H. L. Sumner, Jr.  
Vice President  
Hatch Project

NL-05-1362

Edwin I. Hatch Nuclear Plant  
Supplement to Technical Specifications Revision Request to  
Standby Liquid Control Figure 3.1.7-1

### Edwin I. Hatch Nuclear Plant Supplement to Technical Specifications Revision to Standby Liquid Control Figure 3.1.7-1

Figure 3.1.7-2 (page 1 of 1)  
Sodium Pentaborate Solution Temperature  
Versus Concentration Requirements

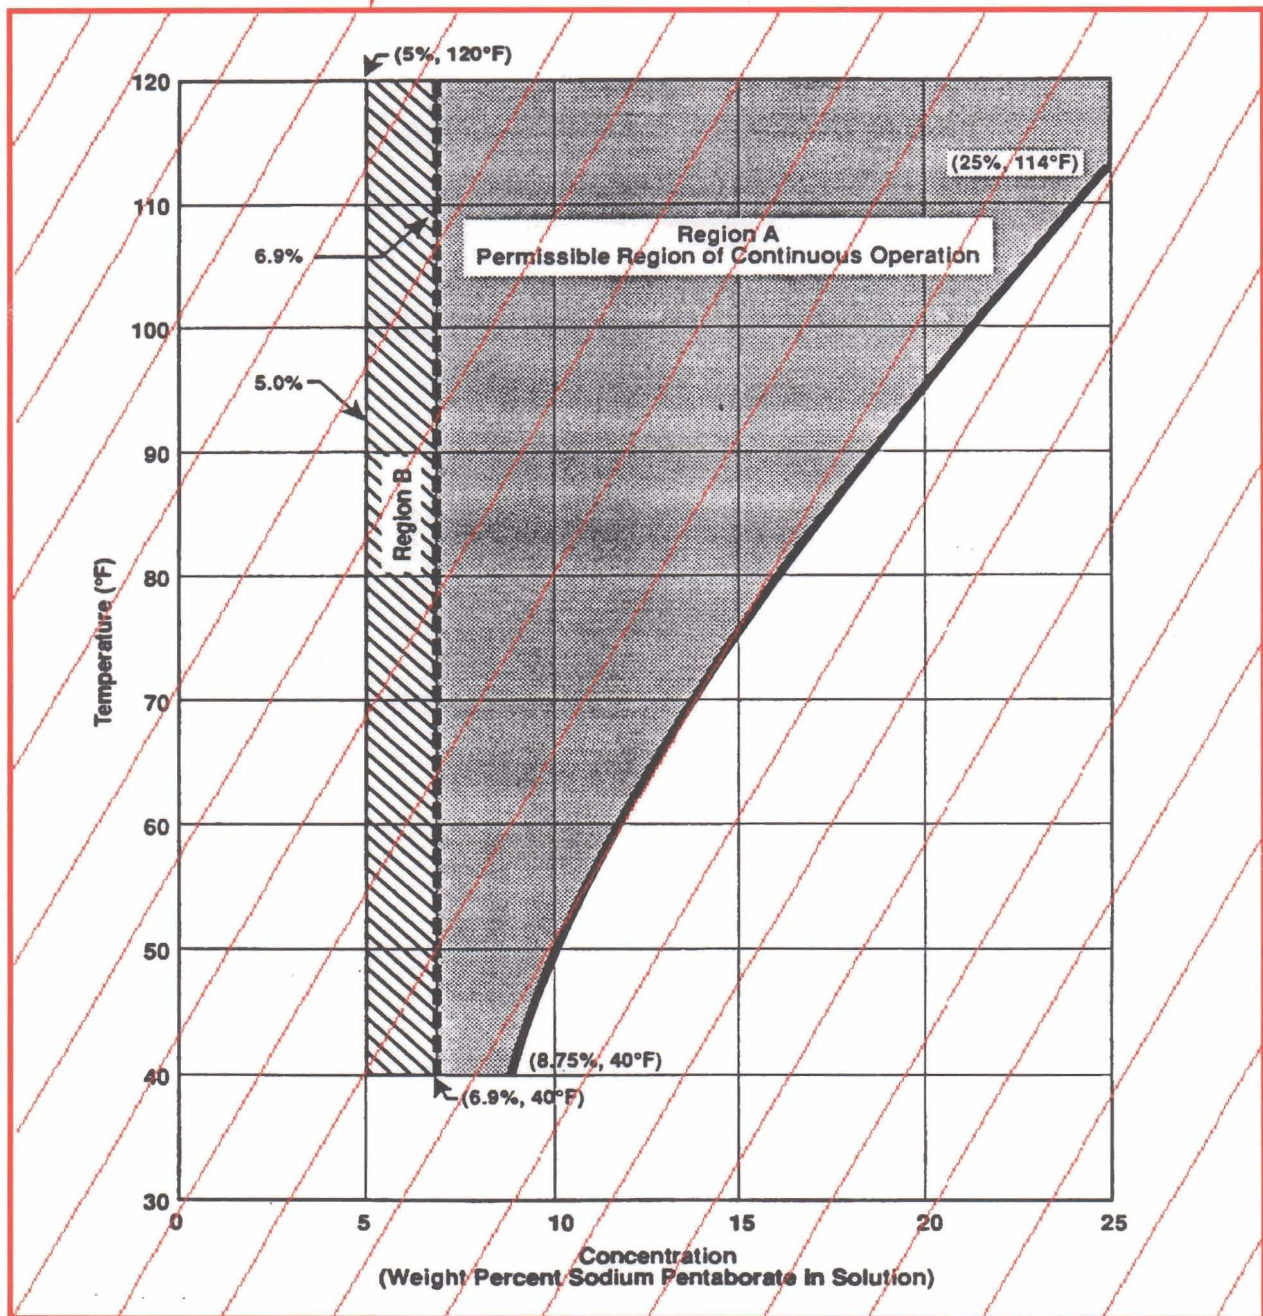
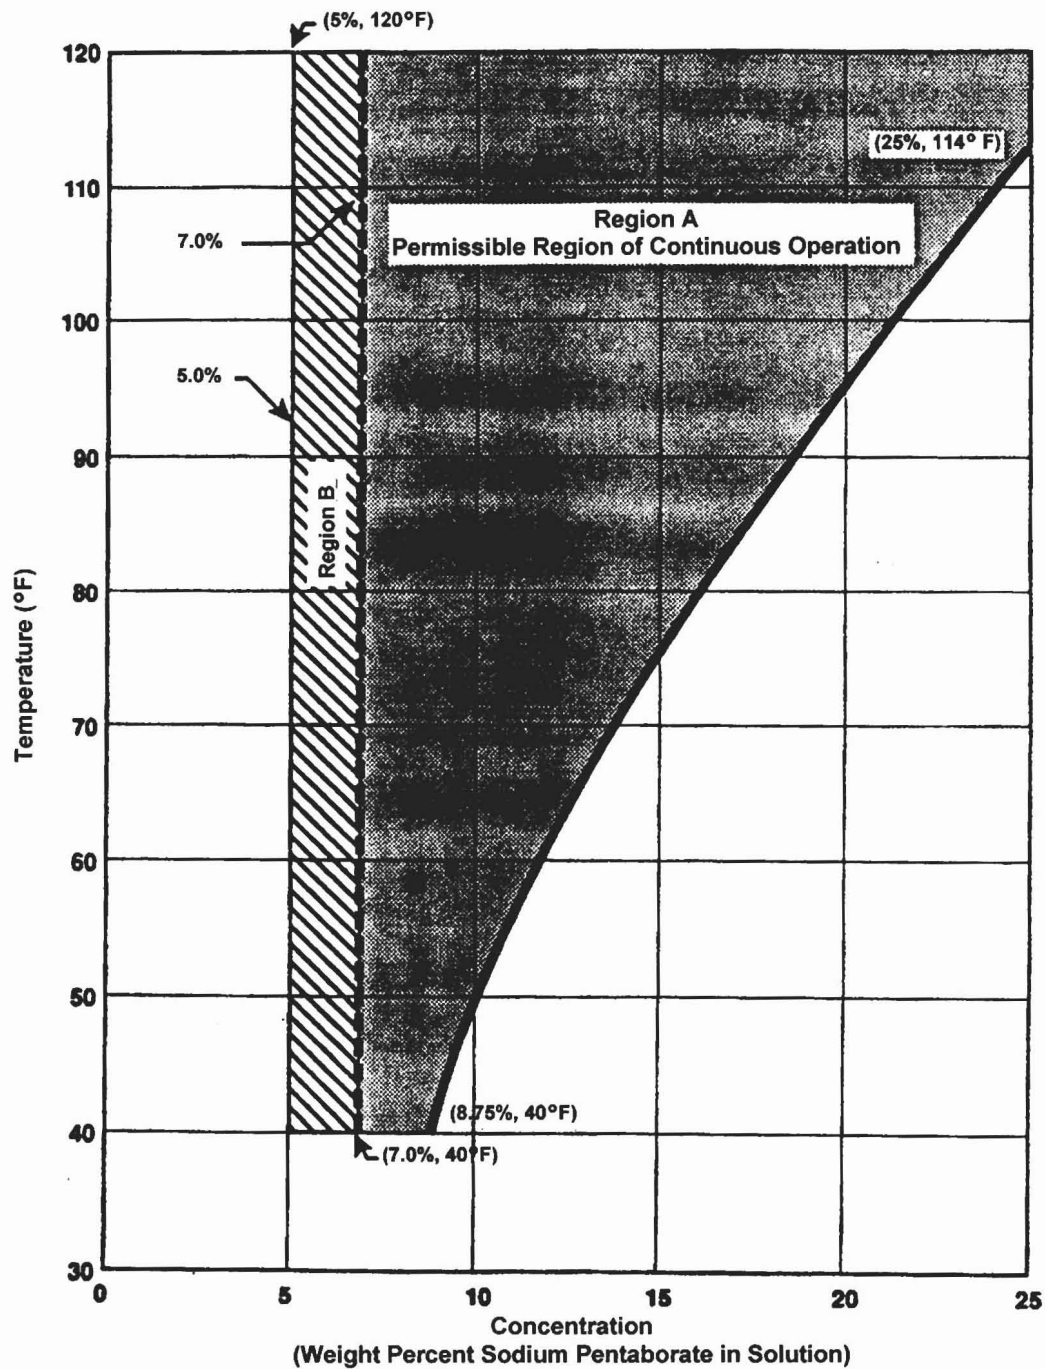
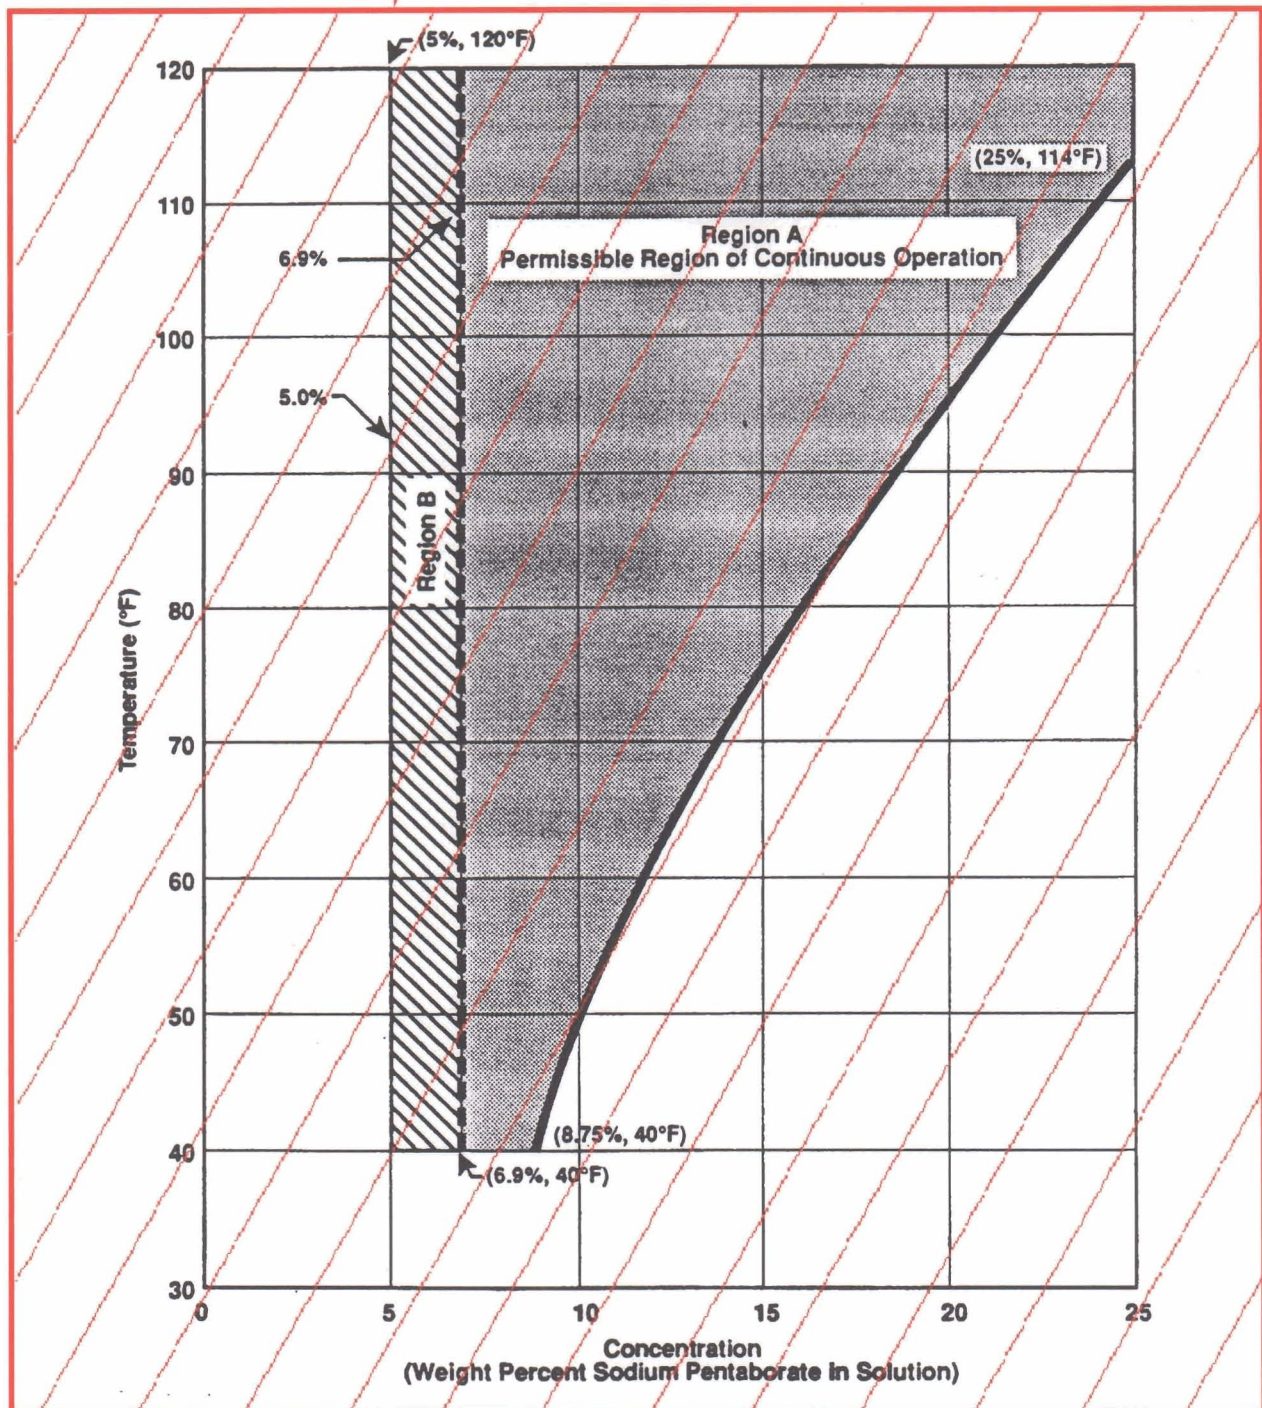
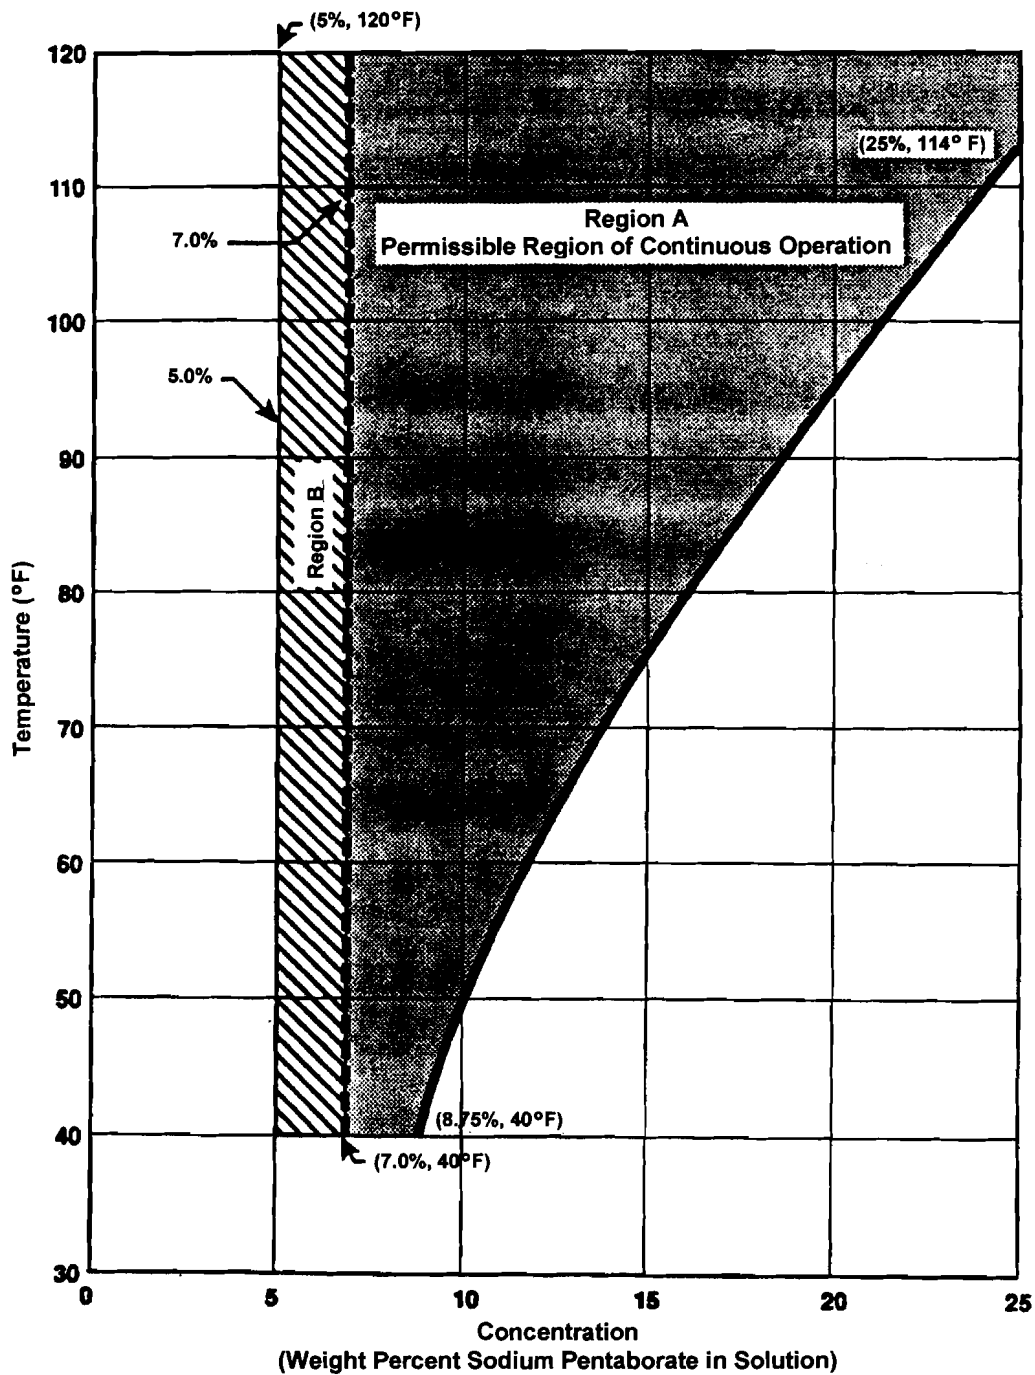
In reviewing the response to a Request for Additional Information on SNC's November 12, 2004 submittal, a round off inconsistency in the translation of the equivalency determination calculation into the current TS Figure 3.1.7-1 was noted. To eliminate that inconsistency, SNC proposes to change the minimum concentration of sodium pentaborate as depicted in both Figures 3.1.7-1 and 3.1.7-2 from 6.9% to 7.0%.

Figure 3.1.7-1 of the Units 1 and 2 Technical Specifications (TS) is being changed to reflect the increased concentration requirements of Boron-10 that must be injected into the reactor vessel, following an ATWS event, and to increase the minimum concentration of Region A from 6.9% to 7.0%. Figure 3.1.7-2, is also being changed to reflect the increase in the minimum concentration.

concentration of Boron-10 atoms in the reactor will be 800 ppm natural Boron equivalent. This is necessary to accommodate increased cycle energy requirements for the Hatch Units 1 and 2 cores. Both Figures 3.1.7-1 and 3.1.7-2 are changed to reflect that the boundary between Region A and B is changing from 6.9% to 7.0%. The proposed change to the Figures will not increase the probability of an ATWS event because the curves have nothing to do with the prevention of an ATWS event. The new requirements will insure that, in the future, the core will have adequate shutdown margin to mitigate the consequences of an ATWS event.

Replace with attached figure

Replace with attached figure
